DEPARTMENT OF ENVIRONMENTAL MANAGEMENT
 OFFICE OF WATER RESOURCES
 FRESHWATER WETLANDS PROGRAM
 APPROVED WITH CONDITIONS
 AS SPECIFIED IN THE LETTER OF APPROVAL
 DATED NOV. 04, 2011 FILE # 11-0138
 NO CHANGES ALLOWED WITHOUT PRIOR APPROVAL.
 APPROVED PLANS MUST BE AT CONSTRUCTION SITE.

PREPARED FOR:
 RHODE ISLAND RESOURCE RECOVERY CORPORATION
 JOHNSTON, R.I.

SITE PLAN & SYSTEM LAYOUT
 REQUEST FOR PRELIMINARY DETERMINATION
 ASSESSOR'S PLAT 43, LOT 567
 CENTRAL LANDFILL
 65 SHUN PIKE, JOHNSTON, RHODE ISLAND

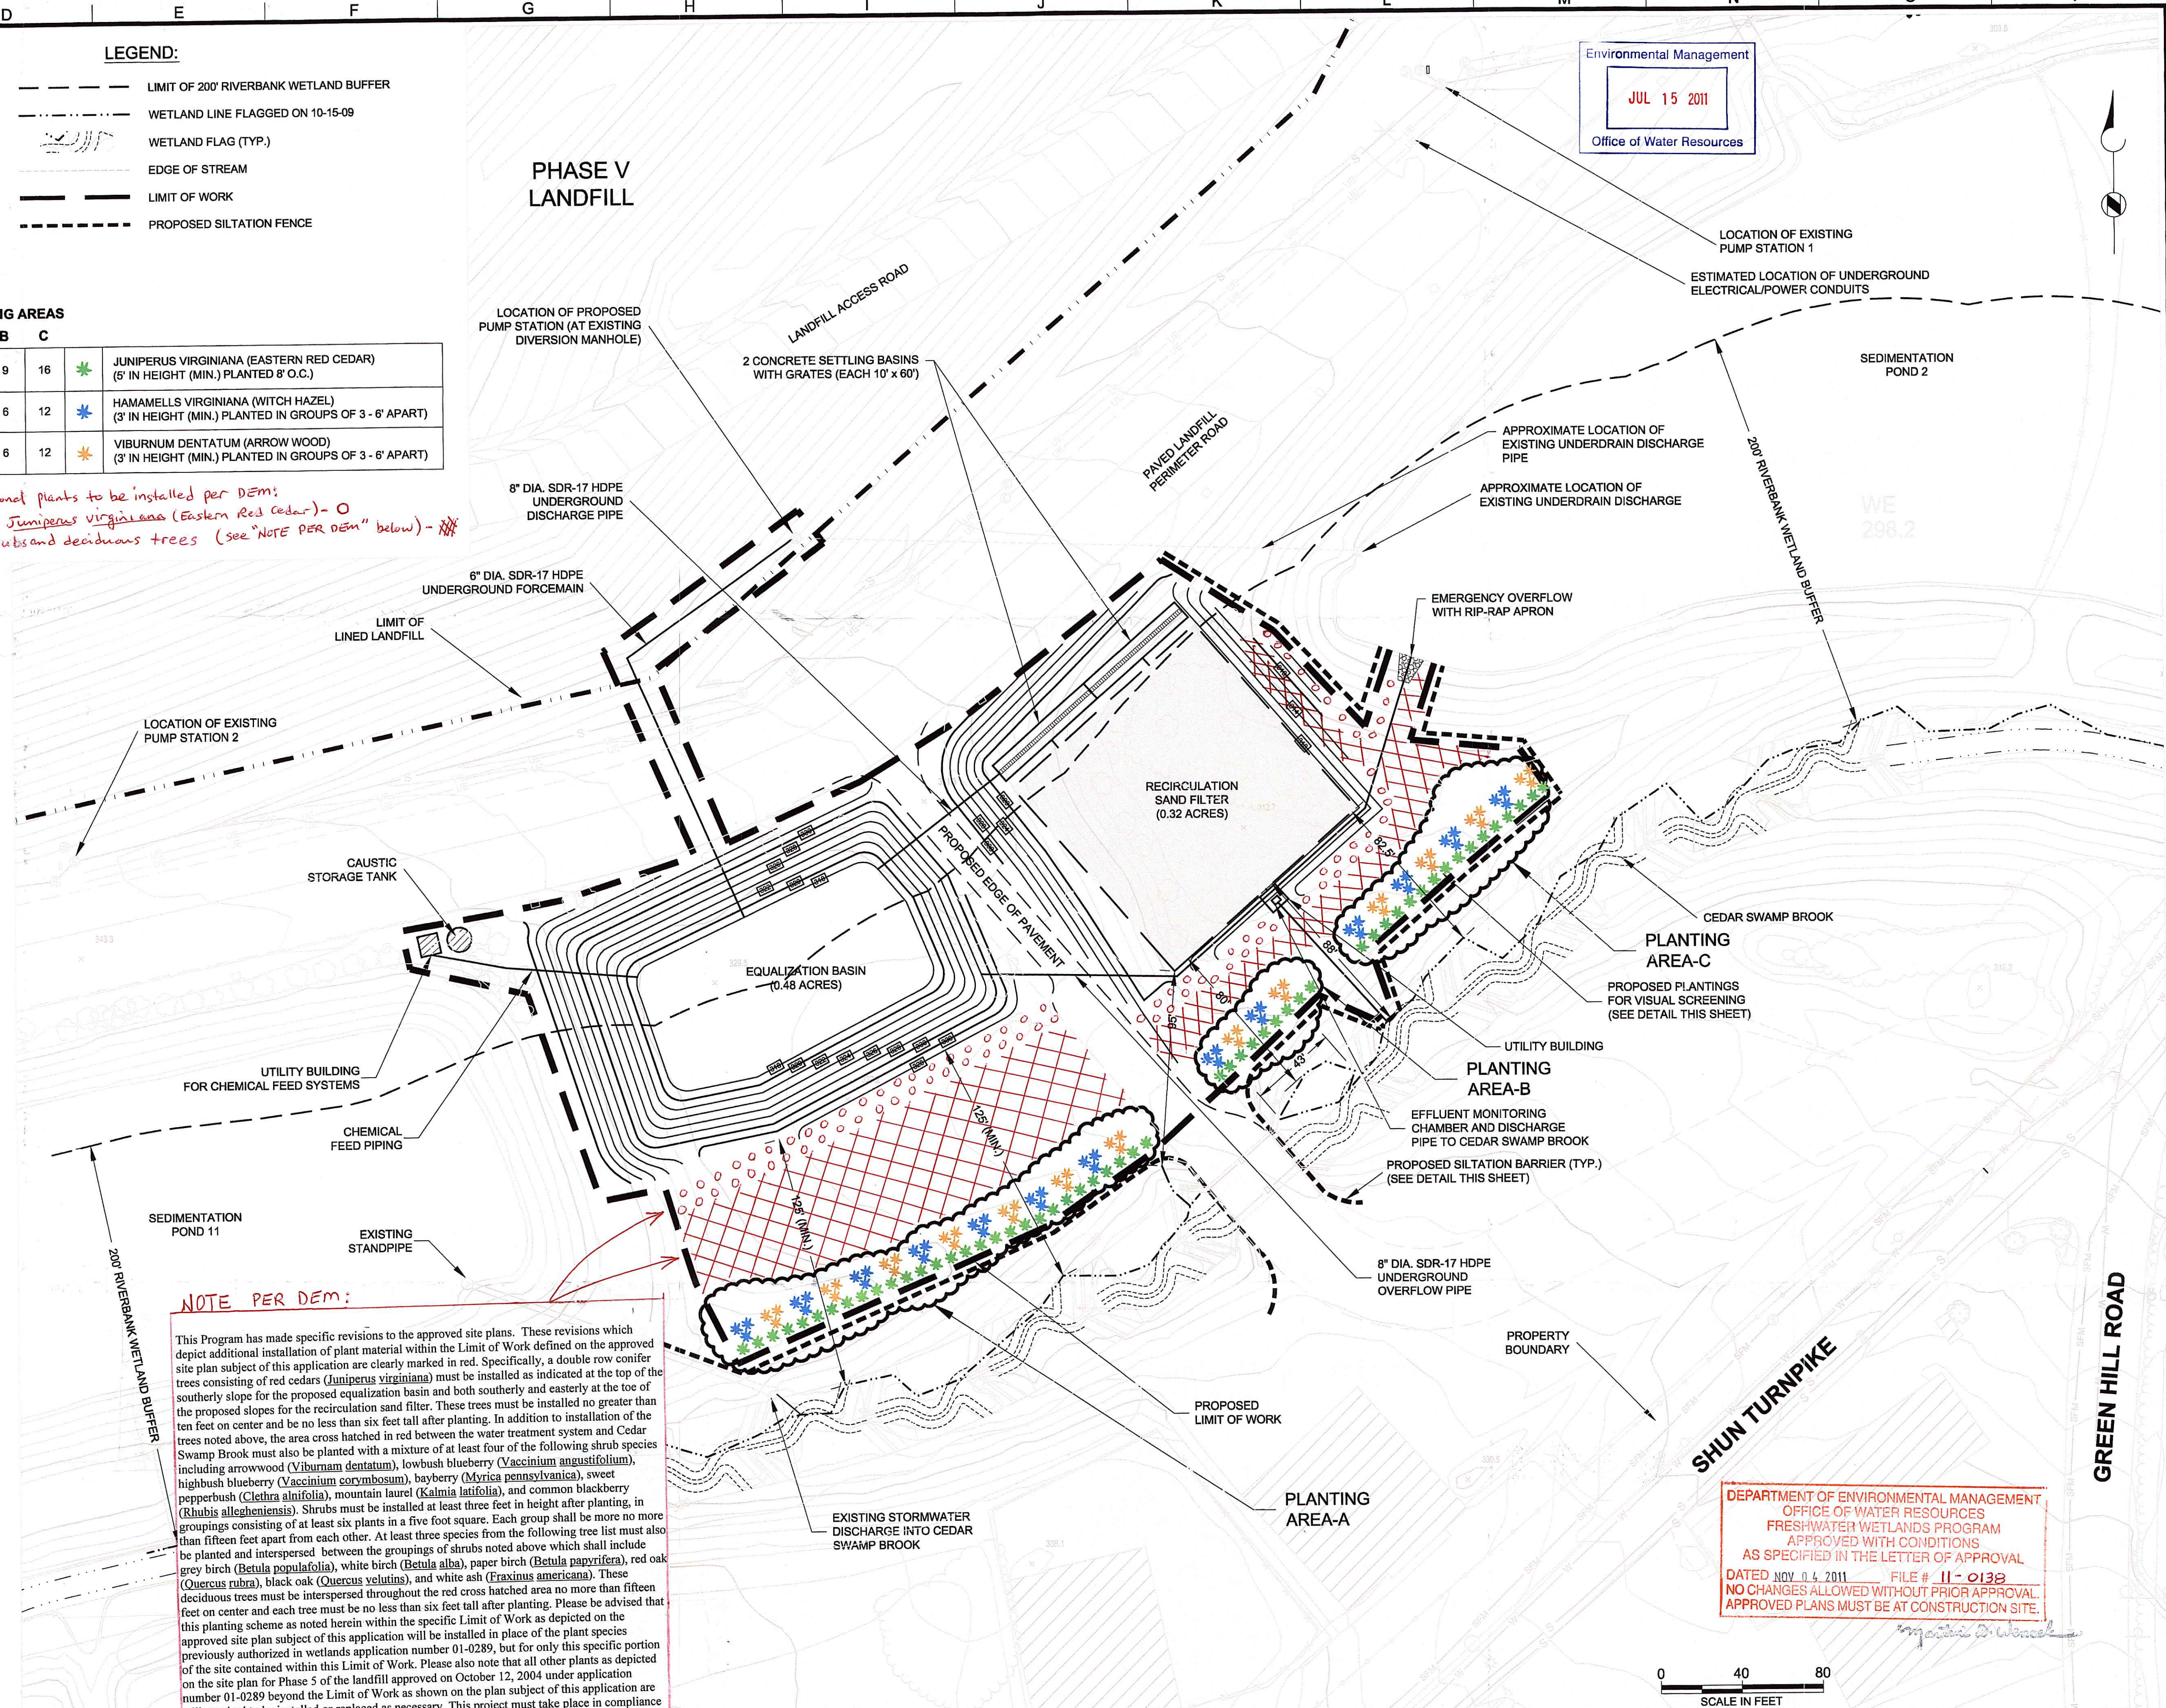
Additional plants to be installed per DEM:
 • 84 Juniperus virginiana (Eastern Red Cedar) - O
 • Shrubs and deciduous trees (see "NOTE PER DEM" below) - O

This Program has made specific revisions to the approved site plans. These revisions which depict additional installation of plant material within the Limit of Work defined on the approved site plan subject of this application are clearly marked in red. Specifically, a double row conifer trees consisting of red cedars (*Juniperus virginiana*) must be installed as indicated at the top of the southerly slope for the proposed equalization basin and both southerly and easterly at the toe of the proposed slopes for the recirculation sand filter. These trees must be installed no greater than ten feet on center and be no less than six feet tall after planting. In addition to installation of the trees noted above, the area cross hatched in red between the water treatment system and Cedar Swamp Brook must also be planted with a mixture of at least four of the following shrub species including arrowwood (*Viburnum dentatum*), lowbush blueberry (*Vaccinium angustifolium*), highbush blueberry (*Vaccinium corymbosum*), bayberry (*Myrica pennsylvanica*), sweet pepperbush (*Clethra alnifolia*), mountain laurel (*Kalmia latifolia*), and common blackberry (*Rubus allegheniensis*). Shrubs must be installed at least three feet in height after planting, in groupings consisting of at least six plants in a five foot square. Each group shall be more no more than fifteen feet apart from each other. At least three species from the following tree list must also be planted and interspersed between the groupings of shrubs noted above which shall include grey birch (*Betula populifolia*), white birch (*Betula alba*), paper birch (*Betula papyrifera*), red oak (*Quercus rubra*), black oak (*Quercus sp.*), and white ash (*Fraxinus americana*). These deciduous trees must be interspersed throughout the red cross hatched area no more than fifteen feet on center and each tree must be no less than six feet tall after planting. Please be advised that this planting scheme as noted herein within the specific Limit of Work as depicted on the approved site plan subject of this application will be installed in place of the plant species previously authorized in wetlands application number 01-0289, but for only this specific portion of the site contained within this Limit of Work. Please also note that all other plants as depicted on the site plan for Phase 5 of the landfill approved on October 12, 2004 under application number 01-0289 beyond the Limit of Work as shown on the plan subject of this application are still required to be installed or replaced as necessary. This project must take place in compliance with these revisions.
